SEV97-0123

mailed 2-10-97
REQUEST FOR SERVICE

County of Sonoma
 Permit And Resource Management Department
 Well & Septic Section
 2550 Ventura Avenue, Santa Rosa, CA 95403 (707) 527-1900

Location Address <i>201 Bohemian Drive</i>		City, Zip <i>Treasure Island CA 94722</i>	
Owner/Facility Name <i>Lloyd Dupper</i>		Assessor's Parcel # <i>073-11-32</i>	
Address of Owner <i>201 Bohemian Drive</i>		City, State, Zip <i>Treasure Island CA 94722</i>	
Person Requesting Service <i>Dupper c/o Rok Duffman</i>		Phone <i>823-2190</i>	
Address of Person Requesting Service <i>876 Havenstien Dr S.</i>		City, State, Zip <i>Sebastopol CA 95472</i>	
Description <i>Evaluate for addition to home</i>			
			By

Site map:

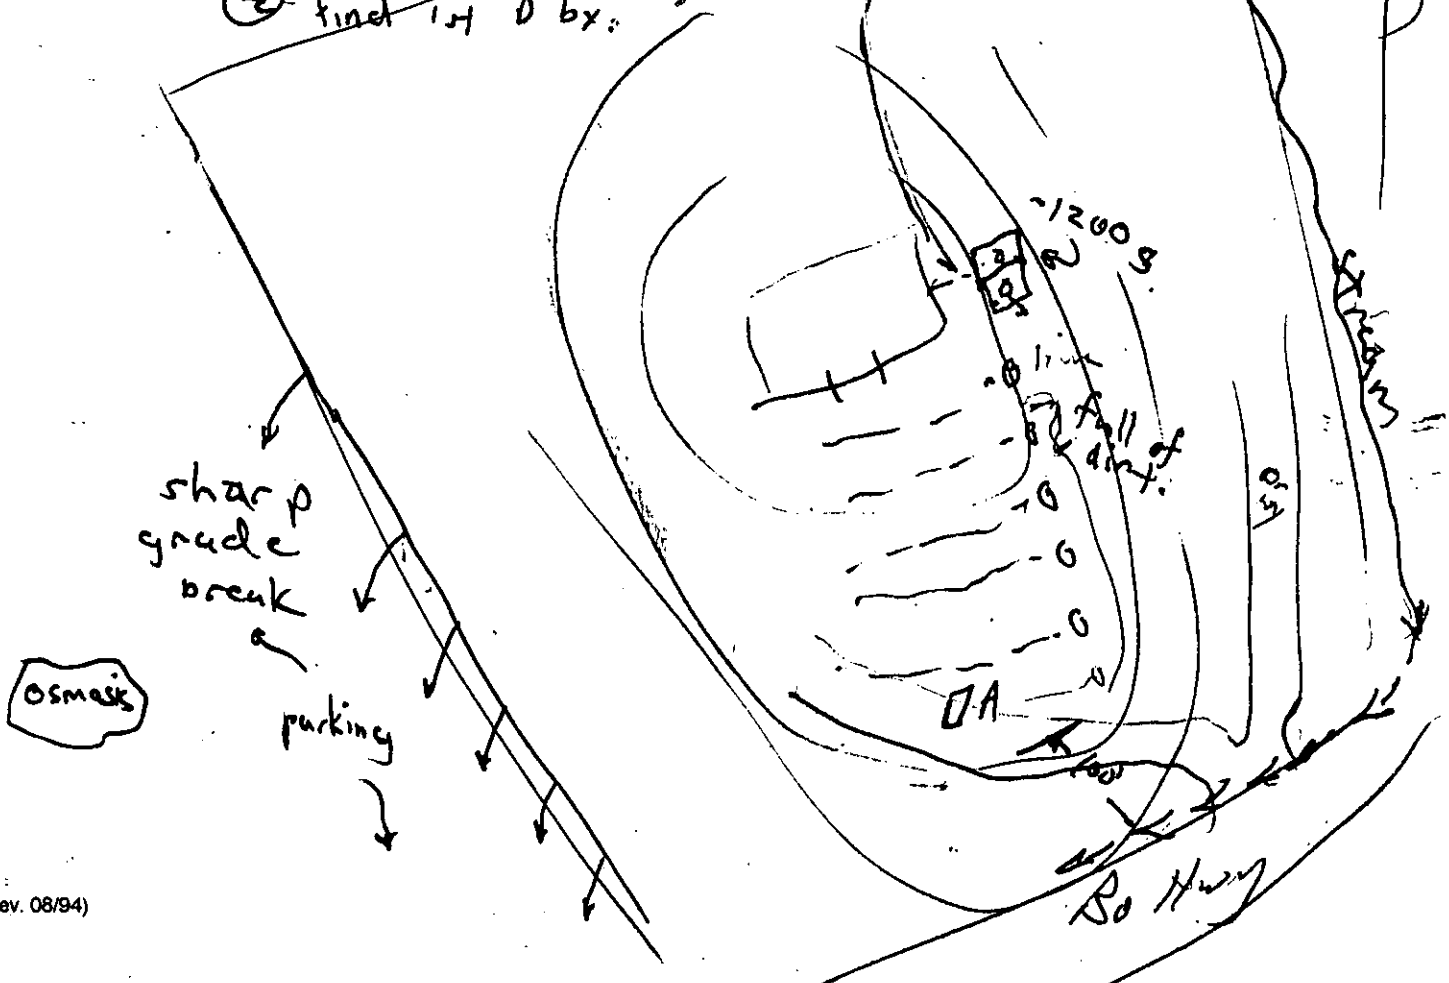
plot plan show ① creek setback.
② find 1st D box:
